## Proposal for amendments to ECE/TRANS/WP.29/GRE/2013/57 Regulation No. 48

### I. Proposal

Para. 6.2.6.1.3., Figure , delete and replace by:

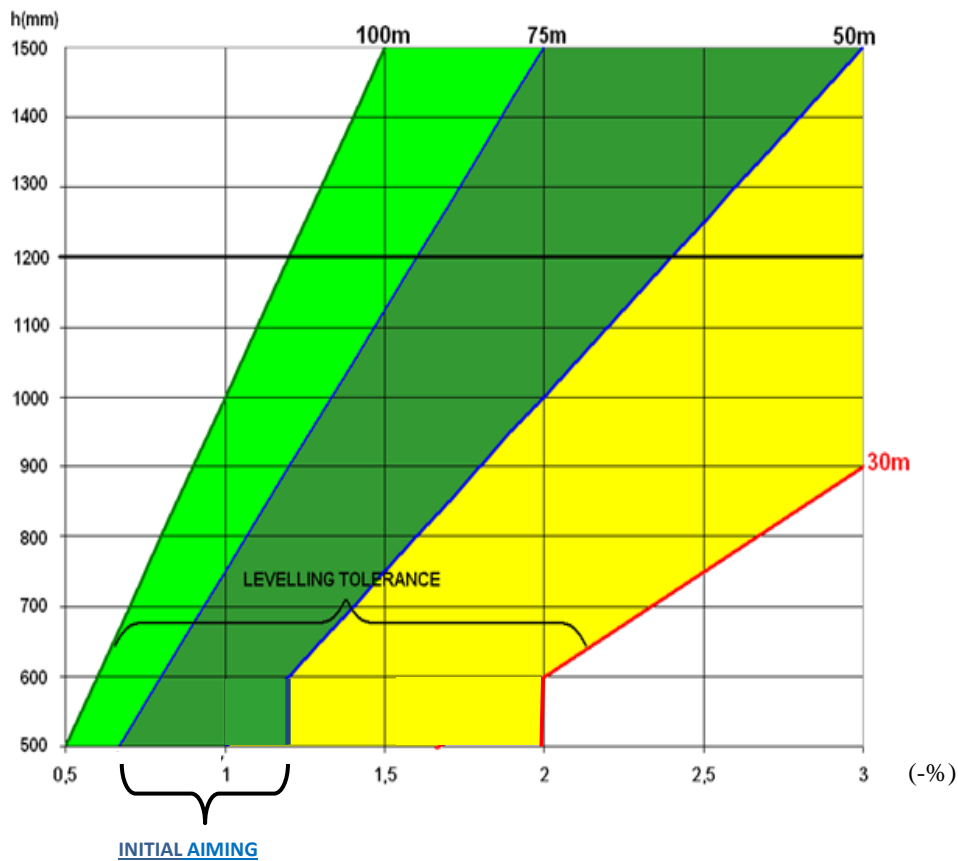
The tolerance bands in Figure in 6.2.6.1.3 of GRE/2013/57 must cover all parameters that influence the static pitch angle under vehicle loading conditions, and achieve common settings for the manual leveling system on all variants of a vehicle type.

From a technical and practical perspective it is not feasible for this option to reduce the tolerance range for dipped-beam initial aim on very low mounted headlamps. i.e. <600mm. Therefore the tolerance specified in paragraph 6.2.6.1.3 requires expanding as proposed in the revised diagram
